**EXHIBIT B: Comments Received with Staff Responses**

TX16-01: Minor Text Amendment to Subdivision Code

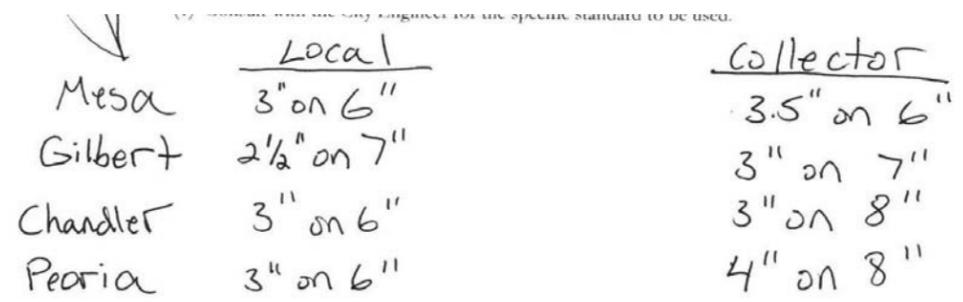
4	How did the City arrive at a 74' median width?	Section 14-6-8 Figure 6	N/A	Parkway standard is based on the Arizona Parkway design guidelines prepared for Maricopa County Department of Transportation. The typical section for a six lane parkway indicates a 74' median. The section was adapted within the 200 ROW to better address non-motorized needs, but the median width and right of way remain consistent with the design guideline.
5	I don't like the minimum pavement thicknesses, specifically on local streets. I think it should read that the pavement thicknesses will conform with the soils report recommendation. I would push for 2.5" on 6" as the min.	Section 14-6-8 Table 4	Decline	The minimum structural sections are being updated to reflect the current industry standards of mix design, standard lift thickness and life cycle costs. A review of comparable local municipal standards was conducted and the findings showed that the updated structural sections are in conformance with accepted norms. The City's experiences with previously constructed pavements show premature pavement failures that result in unacceptable costs of maintenance to the City and residents.
